Staff Report

Re: PLNSUB2014-00137 – Conditional Building & Site Design Review PLNPCM2014-00138 – Planned Development PLNPCM2014-00287 – Special Exception 1202 E. Wilmington Avenue Mixed Use Development

Conditional Building & Site Design Review, Planned Development, and Special Exception

PROPERTY ADDRESS: 1202 E. Wilmington Avenue PARCEL IDs: 16-20-276-054, 16-20-276-057, and 16-20-276-029 MASTER PLAN: Sugar House Community Master Plan ZONING DISTRICT: CSHBD-1, Sugar House Business District

ATTACHMENT C: BUILDING ELEVATIONS

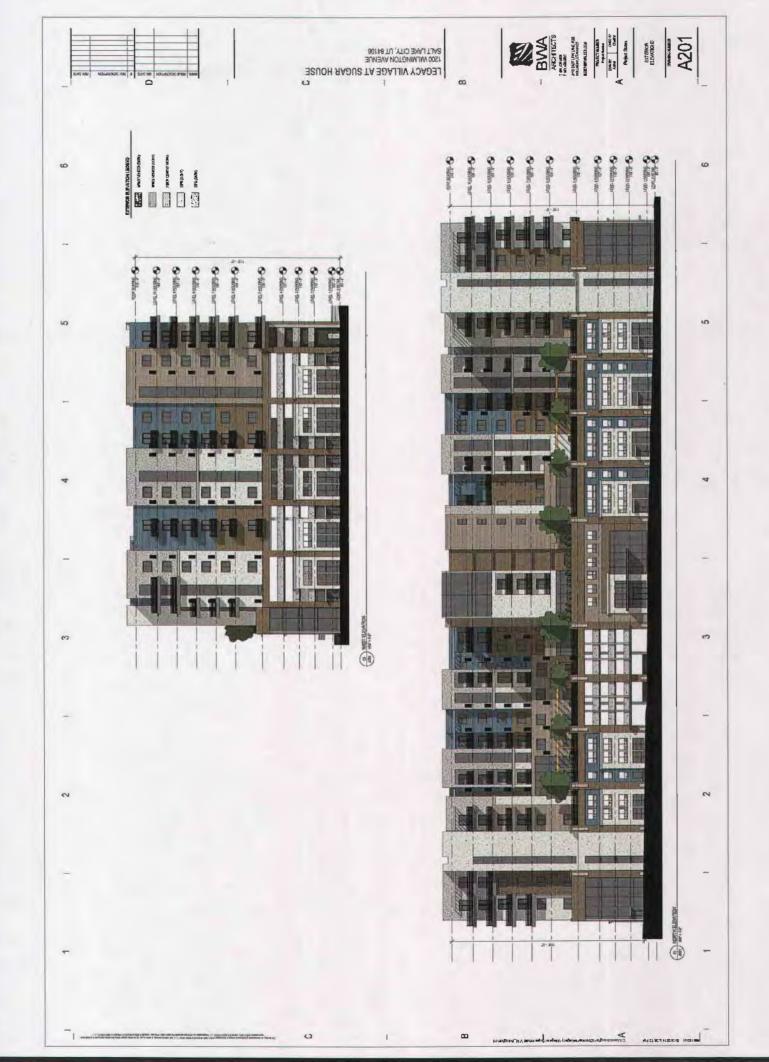
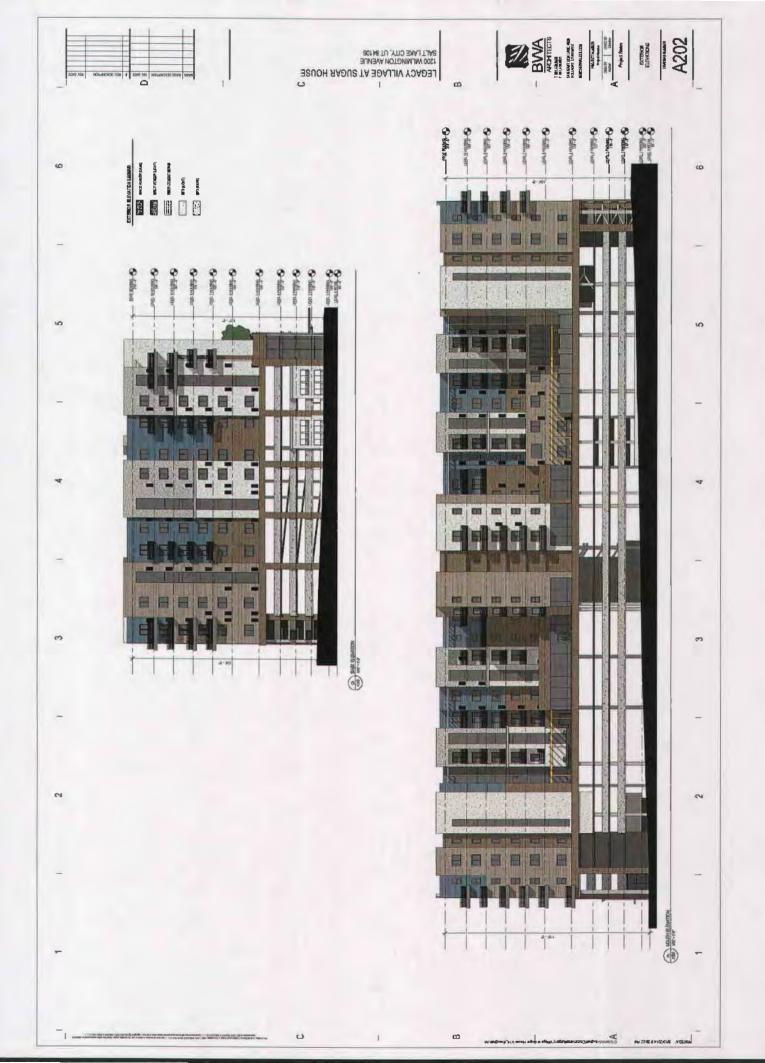
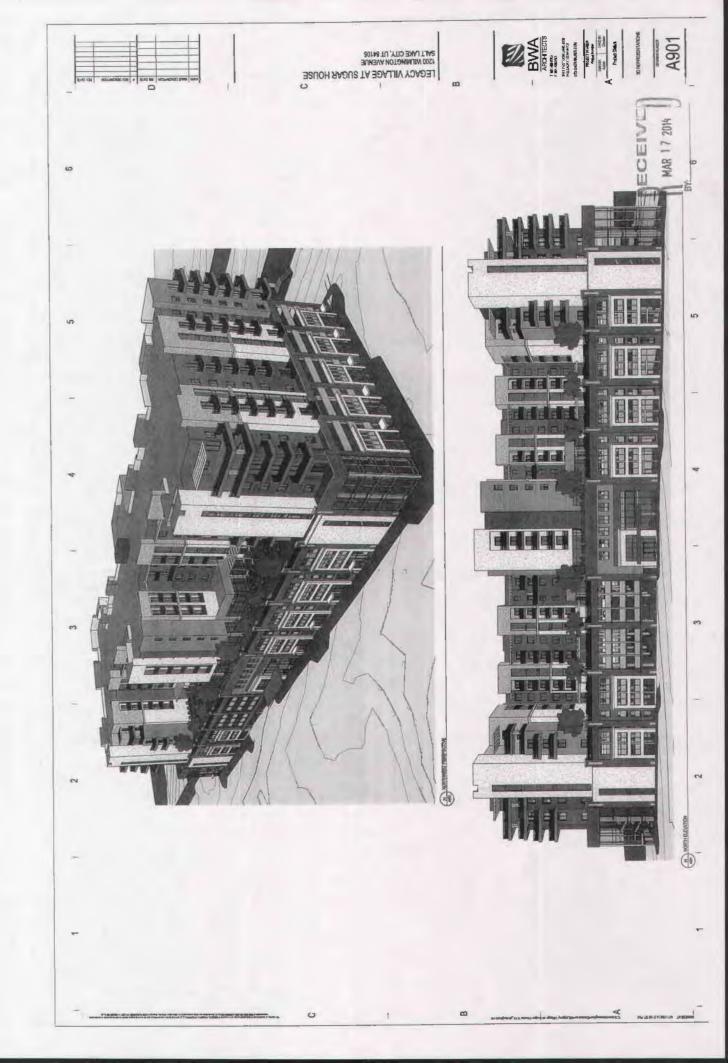
Planning Staff contends that it is possible to construct this building/project without exceeding the maximum building height regardless of slope. There are several means by which this could be accomplished, including but not limited to, grading the site to eliminate the slope challenge, constructing a level of parking underground, and/or the reconsidering the magnitude of the development and scale it back to meet the zoning requirements. Planning Staff asserts: that the building height zoning requirement can be met, and there is no compelling argument, including slope, to recommend that the standard be relaxed.

Planning Staff's concern with the proposed building height is twofold. First, the proposed building height of 115 feet does not conform to the community vision that was adopted in the Sugar House Master Plan, unplemented by the CSHBD Zoning Standards, for the Sugar House Business District. The adopted maximum building height standard was adopted for the specific purpose of realizing said vision. A discussion of "Business District Design Guidelines" is attached in Section F - Existing Conditions. These guidelines address building height, scale, and mass, outlining the vision that is desired for the Sugar House Business District. Planning Staff is not in a position to support proposals that do not lend themselves to the community vision outlined in the Master Plan and implemented by the Zoning Ordinance. Second, should the proposed height be allowed, it would be precedent setting. An approval for increased building height is appropriate in the area and further is consistent with the established community vision.

Here again, Planning Staff asserts that this zoning requirement can be met, and there is no compelling argument to recommend that the standard be relaxed.

Based on the information in this staff report, Planning Staff supports the overall concept of the proposed development, however does not support the requested relaxation of zoning standards. Planning Staff recommends that the Planning Commission approve the proposal subject to complying with all applicable zoning regulations as outlined in Section 21A.26.060 – Sugar House Business District. Specifically, the approval is based on the applicant's compliance with:

Section 21A.26.060(G)(1) – Maximum Building Height Section 21A.26.060(G)(3) – Stepback Requirement Section 21A.26.060(J) – First Floor/Street Level Requirements
